Hakanson Anderson
Civil Engineers and Land Surveyors
3601 Thurston Ave., Anoka, Minnesota 55303
763-427-5860 FAX 763-427-0520
www.haa-inc.com

SKETCH PLAN
4-PLEX BUILDING

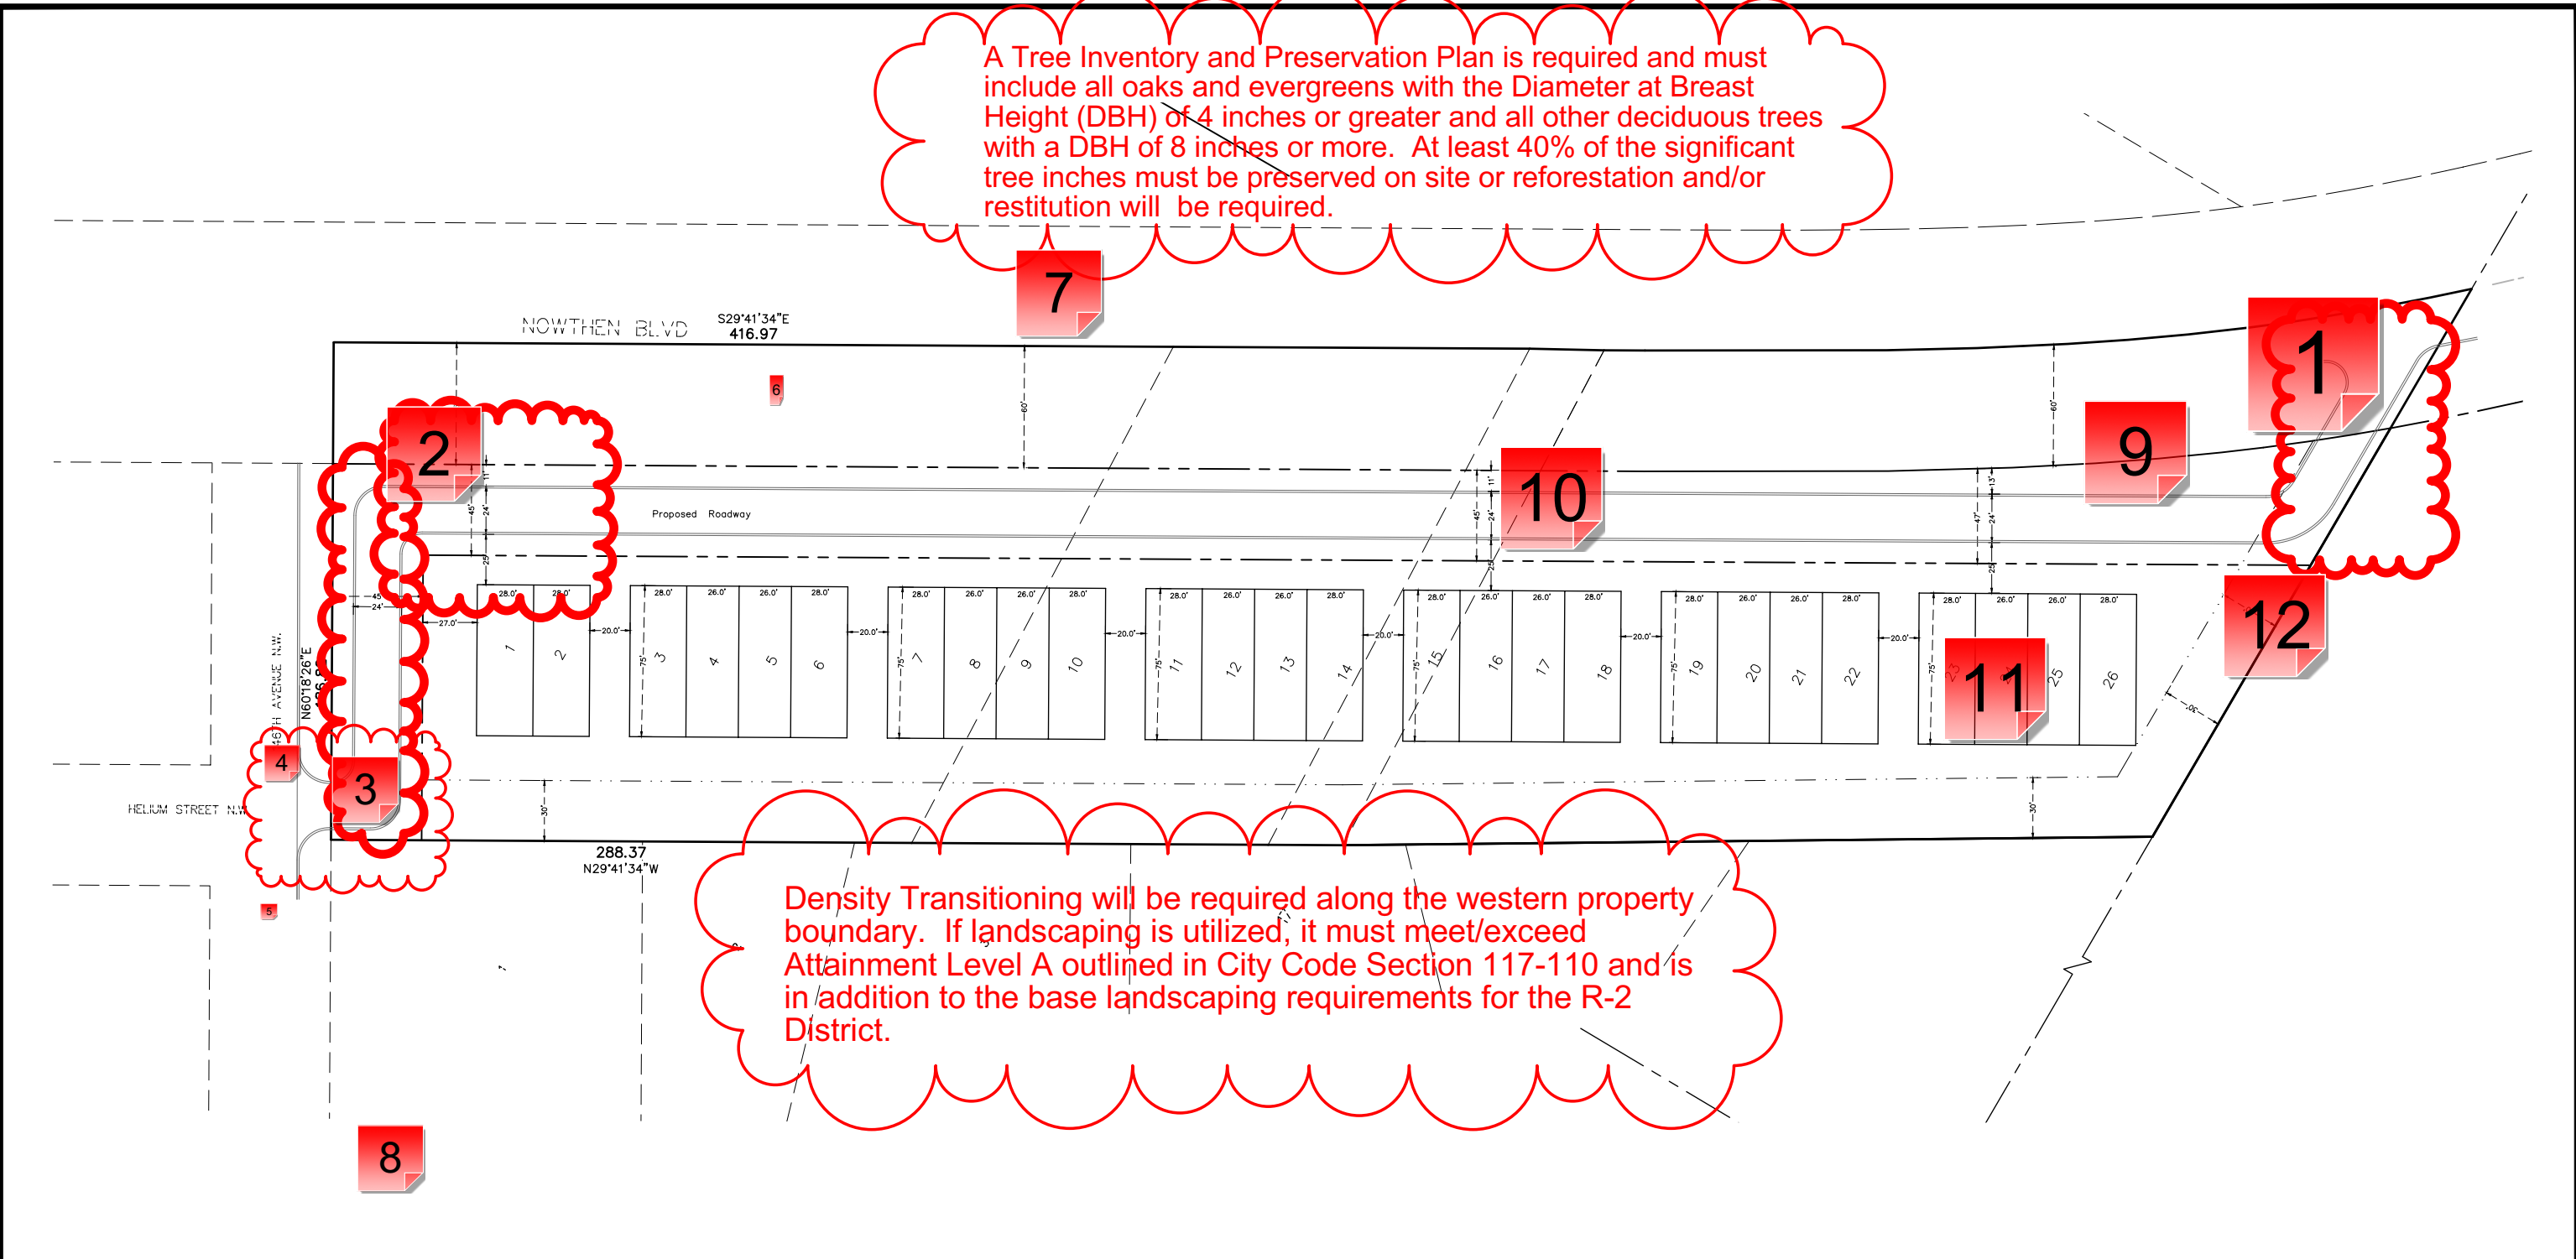
A Tree Inventory and Preservation Plan is required and must include all oaks and evergreens with the Diameter at Breast Height (DBH) of 4 inches or greater and all other deciduous trees with a DBH of 8 inches or more. At least 40% of the significant tree inches must be preserved on site or reforestation and/or restitution will be required.

Density Transitioning will be required along the western property boundary. If landscaping is utilized, it must meet/exceed Attainment Level A outlined in City Code Section 117-110 and is in addition to the base landscaping requirements for the R-2 District.

Is this going to connect to Nowthen BLVD?

This radius, along with the one to the east are both very tight. Consider pushing road slightly to the south and stretching the radii to 15-20 ft?

Very tight, consider widening the entrance/curve to eliminate potential conflicts off of 164th Avenue.

164th Avenue was reconstructed in 2019, any patching into the road would be required to go full width of street, and meet existing pavement section.

Water & Sewer existng on the east side in the western ditch of Nowthen Blvd. Sanitary is 8" PVC, Water is 12" DIP. 146th Avenue water is on the north side of the road, and sanitary is

centerline, same size as above.
Sewer & Water Asbuilts have been uploaded into the Documents Folder.

Several Different Line Types, The major ones need to be identified, preferably add a legend, at a minimum label the lines.

Stormwater ponding for rate control of the 2, 10 and 100 year storms will be required.
Infiltration (volume reduction) will also be required.

Meeting the stormwater requirements will most likely require loss of units or installation of underground storage devices.

Verify that the county will allow an access in this location before proceeding too far with plan development.

Lot 26 is over 1000 feet from 146th Avenue, exceeding the maximum length for dead-end streets.

The county prefers driveways aligned with each other, which would put the access near this spot.
See comments on County Highway Access.

Verify Gravity sewer can serve lot 26.

Watermain must be looped through the project.
